Re: Industrial Park for Warehousing and Logistics Center

Location: 19 Hemion Road, 206 Lafayette Avenue, & 25 Old Mill Road, Suffern, NY 10965
Parcel ID(s): Section 55.06, Block 1, Lot(s) 1, & Section 55.37, Block 1, Lot(s) 31
Section 55.22, Block 1, Lot(s) 1
Municipality: Village of Suffern
Resource: Mahwah River

IV2 Rockland Logistics/Brookfield Properties Review
Suffern, Rockland County, New York
Colliers Engineering & Design Project No. 22004165A

Excerpt of Vehicle Circulation Plan Sheet 1 of 3 - Internal Intersection

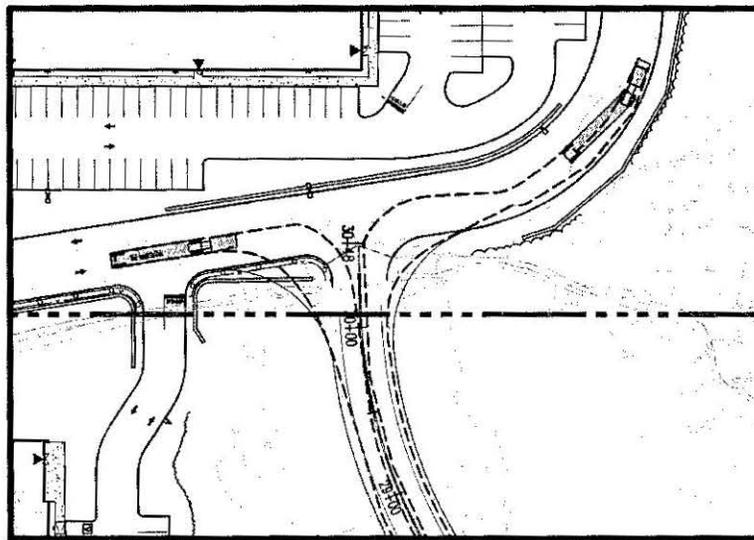
3. In addition to Item 2 above, we note that the Applicant indicated at the Public Hearing that the modifications to the southerly access driveway shown on Vehicular Circulation Plan, Sheet No. 1 of 3 (contained in DEIS Appendix E2) are not proposed to be implemented as part of the Project and that these were only considered as part of the alternate with no Project access to Old Mill Road. However, if trucks are planned to use the southerly access driveway from Hemion Road as noted in Item 2 above, the vehicle circulation path shown on the Sheet 1 of 3 plan indicates that modifications to the southerly access driveway are necessary to accommodate the WB-67 design vehicle. Specifically, widening of the internal intersection of the southerly access driveway at the internal circulation roadway is required as shown in the excerpt below.

III.F.42

Excerpt of Vehicle Circulation Plan Sheet 1 of 3 - Hemion Road Intersection

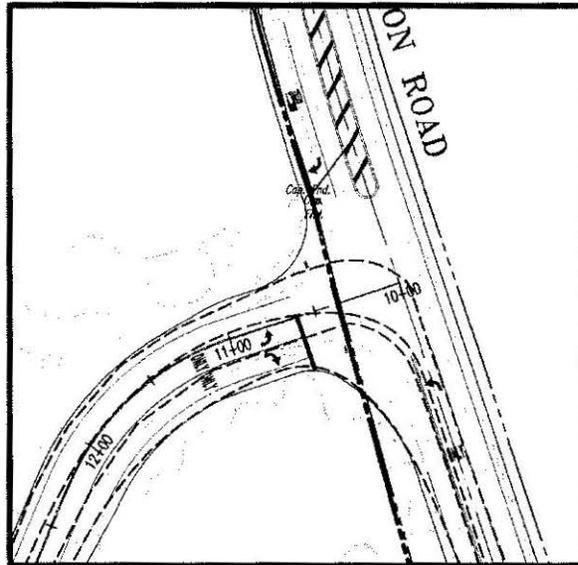
In addition, it appears widening of the southerly access driveway at Hemion Road is also required to accommodate the left turn entry and right turn exit movements for the trucks at this intersection as shown in the excerpt below. This plan also shows widening of Hemion Road to provide a separate northbound left turn lane and a separate southbound right turn lane. The Applicant should further assess the need for these intersection modifications as previously noted in Comment No. 22 in our April 21, 2023 letter.

Lastly, the Vehicular Circulation Plan, Sheet No. 1 of 3 depicts widening of the entire length of the southerly access driveway, which we assume was proposed to accommodate the truck traffic along this roadway. The need for improvements to the entire length of this driveway should be clarified based on the anticipated access scenario.

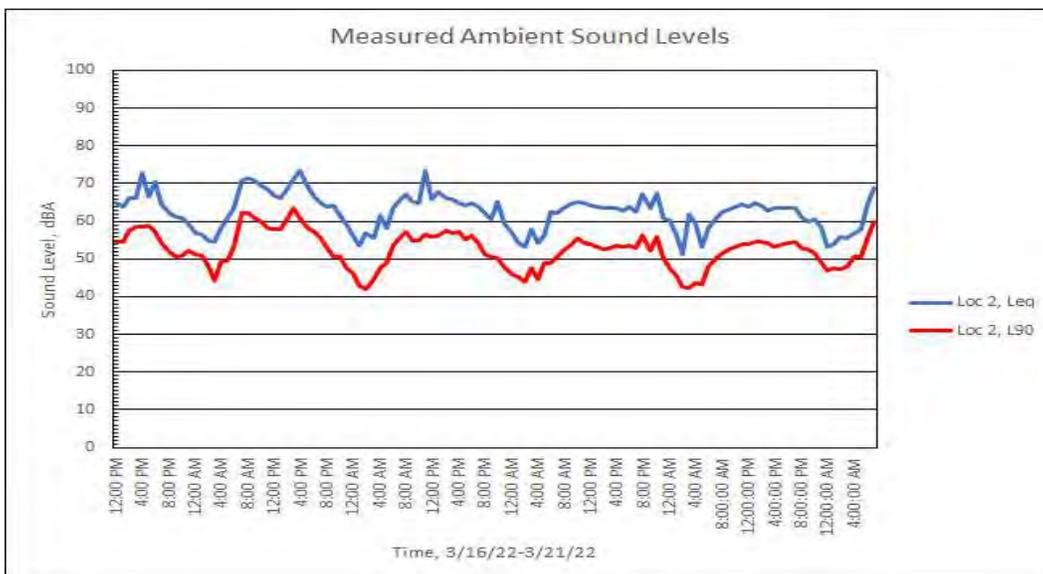
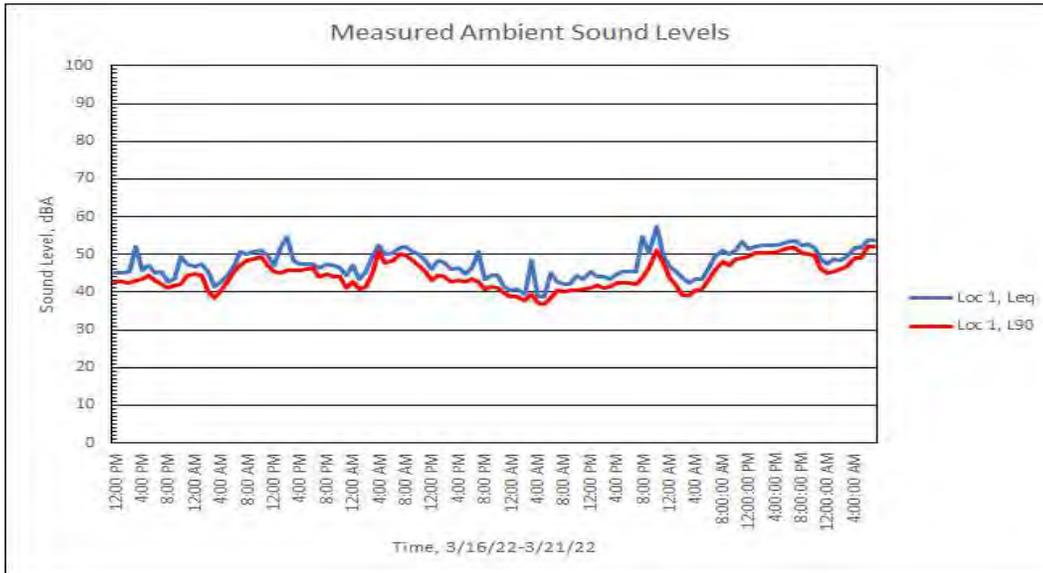
A second survey location was selected on the west side of Hemion Road near Lackawanna Trail, which characterized the ambient sound levels near a medical facility and commercial buildings. An apartment complex is located remote from the road on the east side. The measured ambient sound levels were averaged for the entire survey period, which resulted in a value of 63 dBA L_{eq} and 53 dBA L_{90} at Location 2. The sound levels at the survey location may be influenced by traffic on Hemion Road. The sound levels at Location 2 may represent the ambient sound levels at front facade locations of receptors close to local roadways.

The day-night L_{eq} average ambient sound level of 48 dBA which the developer determined from the logging data at the south location was used as the ambient noise criterion to assess facility noise acceptability at each of the receiver locations. Examinations of plotted ambient sound level time history data shows the sound levels in nighttime hours are lower than this average value, and at times fall under 40 dBA at Location 1 and approximates 55 dBA at Location 2. The following graphs plot the logged hourly-average L_{eq} and L_{90} sound level data. Based on mathematical averaging of the survey data by hours, a 48 dBA criterion is appropriate for the morning peak period (7:00-9:00 a.m.), the afternoon peak period (3:00-6:00 p.m.), the midday period (11:00 a.m.-1:00 p.m.), and an evening period (7:00-9:00 p.m.). For nighttime hours, a criterion of 45 dBA or lower would instead be more appropriate to represent the average ambient L_{eq} sound level from 12:00 a.m. to 4:00 a.m.

Short term ambient sampling surveys were not obtained at the logging locations or at other community locations. Sampling surveys would be desirable to characterize the ambient sound levels at additional sensitive and residential receiver locations south of the project site, and at locations north of the site where logging was not performed.
